WESTAR ADDITION SEDGWICK COUNTY, KANSAS

RE: SUB 2003-135 -- One-Step Final Plat of Westar Addition

CASE NUMBER: SUB 2003-135 -- WESTAR ADDITION

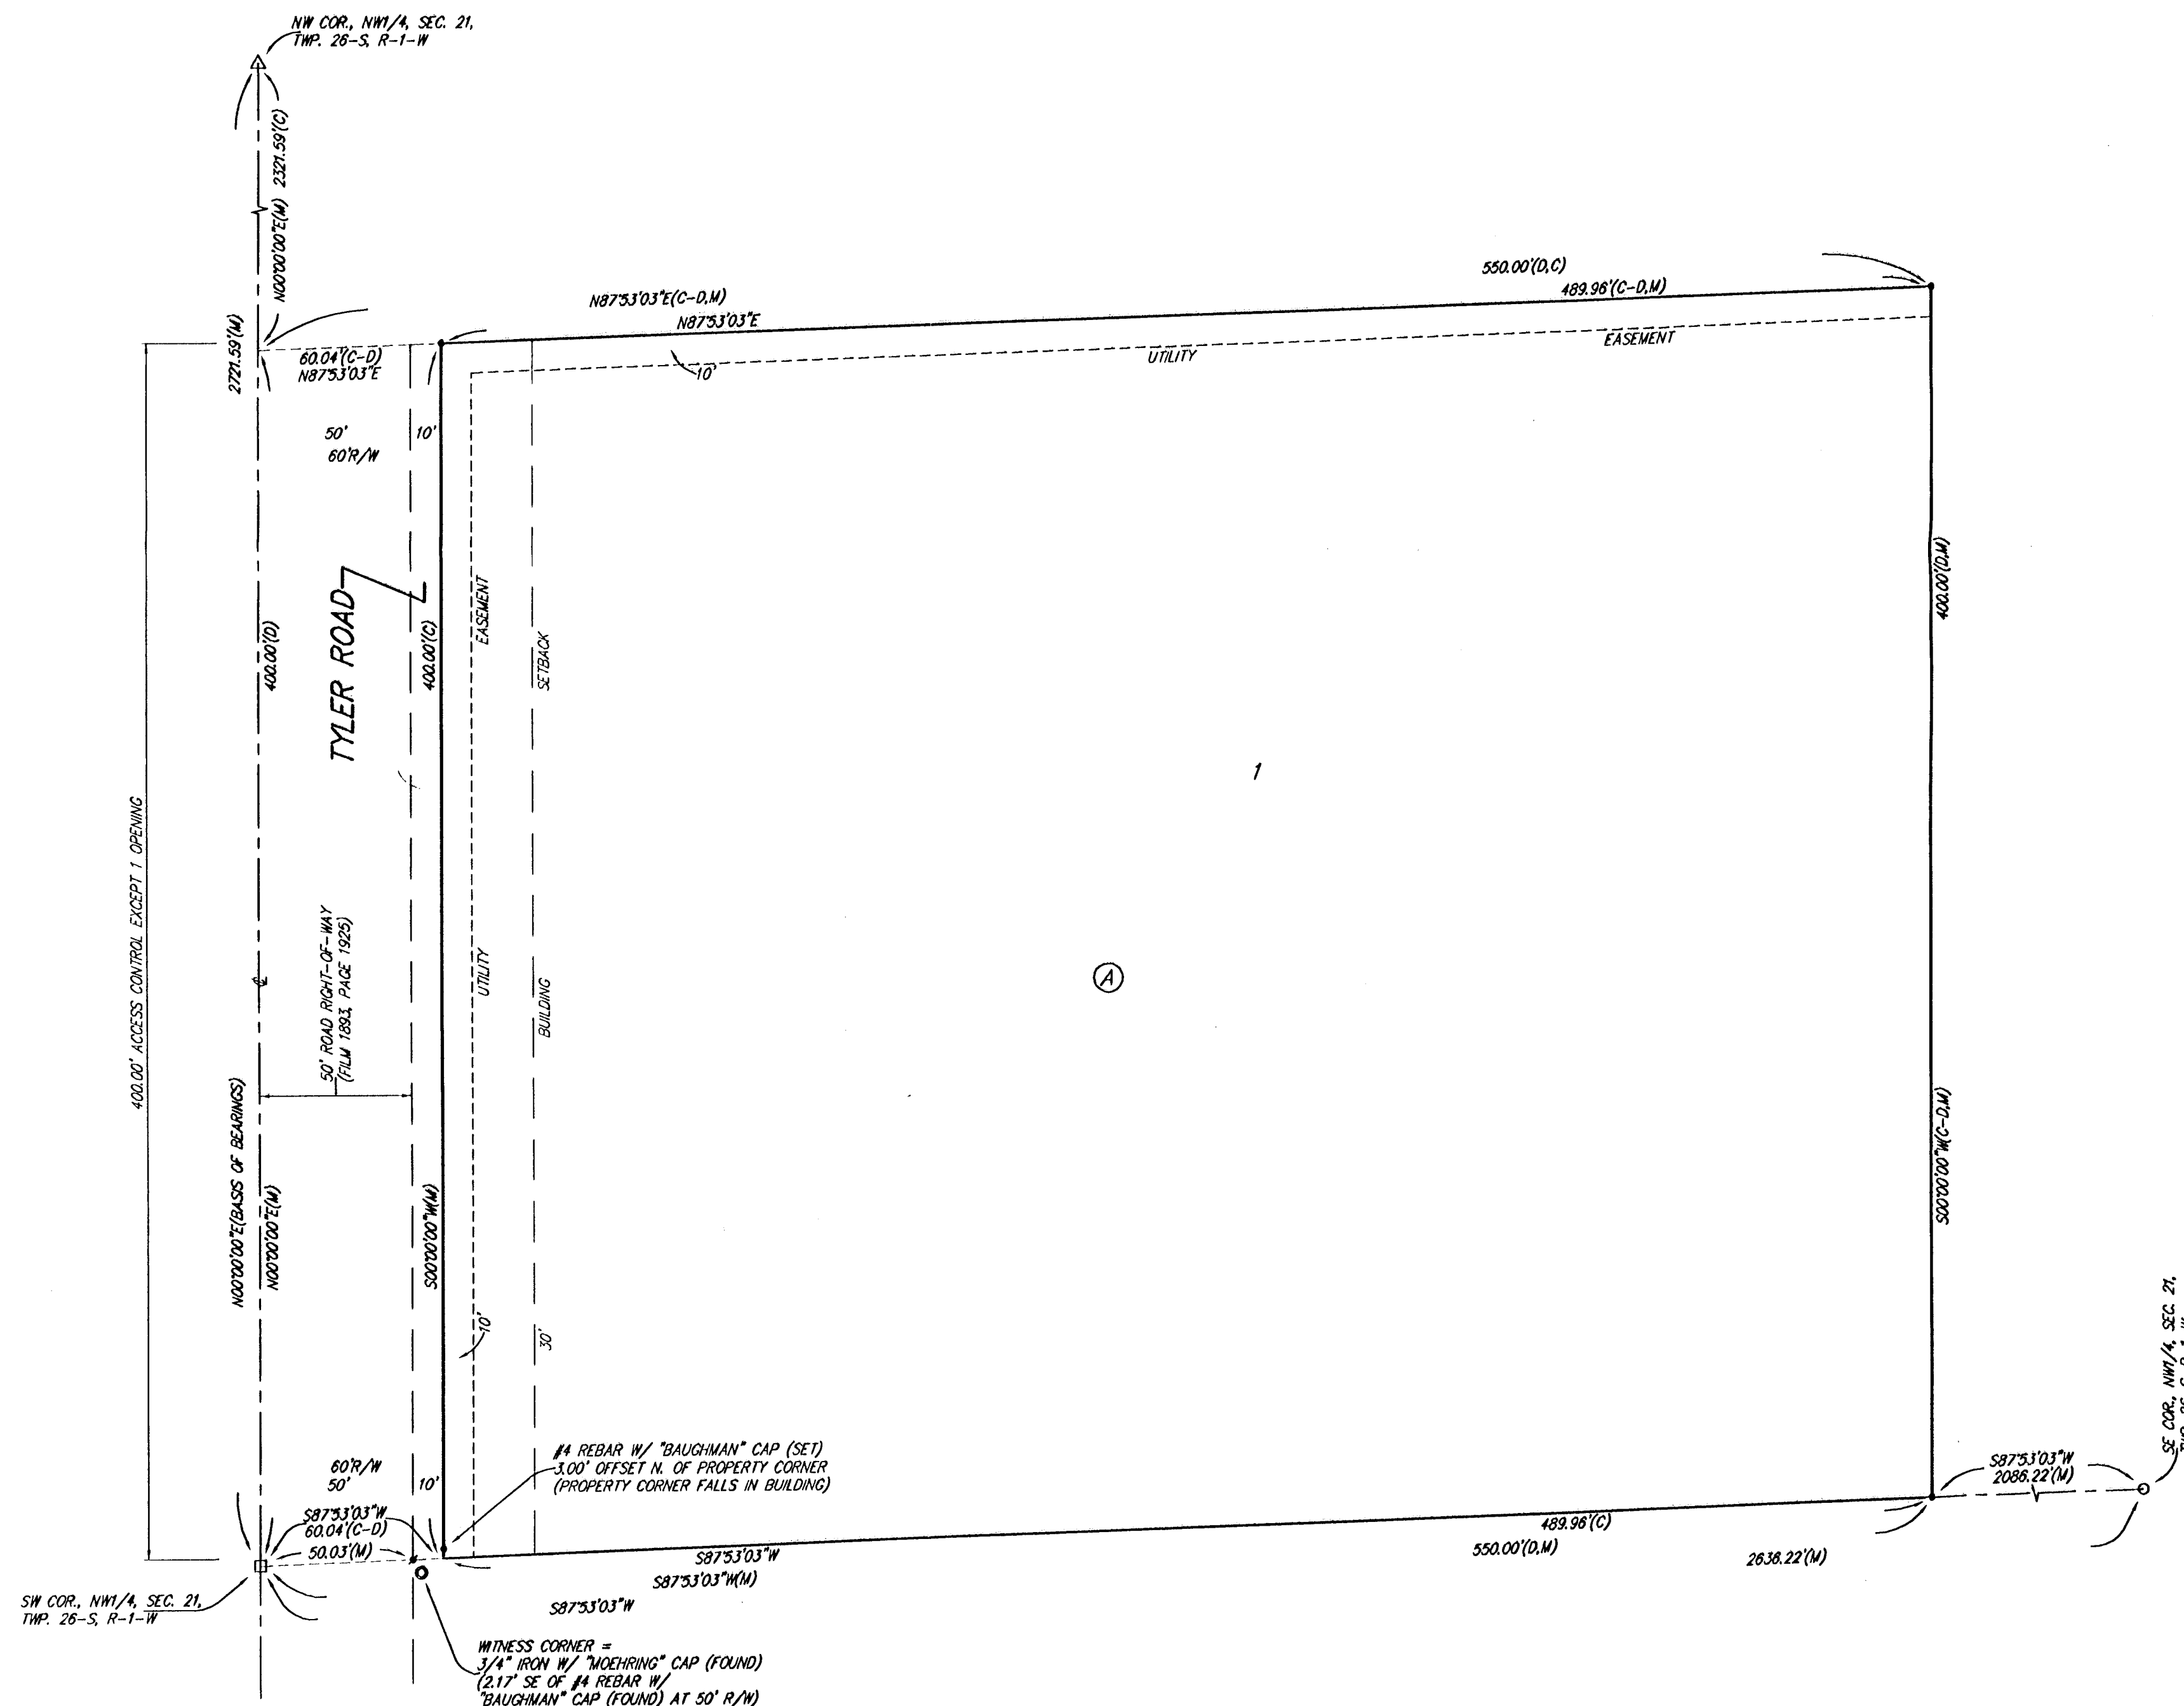
- A. County Engineering needs to comment on the status of the applicant's drainage plan. *The drainage plan is approved.*
- B. County Engineering needs to comment on the access controls. The plat denotes one opening along Tyler. The site plan denotes this opening to be 123 feet from the south property line. *The access controls are approved.*

- C. The final plat tracing shall reference the dedication of access controls in the plat's text to the "appropriate governing body".
- D. Per Sedgwick County Fire Department, access drives to any structure in excess of 150 feet from the edge of the roadway will need to be installed prior to final framing inspection, preferably before the start of any above grade construction work. Such drive to be installed according to fire department specifications: (1) Twenty feet of drivable surface is provided the entire length of the access drive designed to withstand the weight of fire apparatus in inclement weather with provisions for turning fire apparatus around. (2) To meet fire department specifications, the surface will need to be an all-weather material consisting of rock or gravel, ground asphalt, laid asphalt or concrete. It is to be applied a minimum of 4 inches in depth consistently over the entire width and length of the driving surface (gravel is prone to problems during extended periods of rain or snow and should be used with caution unless a good solid compacted base has been installed).

- H. The platting text shall include language that a drainage plan has been developed for the plat and that all drainage easements, rights-of-way, or reserves shall remain at established grades or as modified with the approval of the applicable City or County Engineer, and unobstructed to allow for the conveyance of stormwater.

- J. The applicant's engineer is advised that the Register of Deeds is requiring the name(s) of the notary public, who acknowledges the signatures on this plat, to be printed beneath the notary's signature.
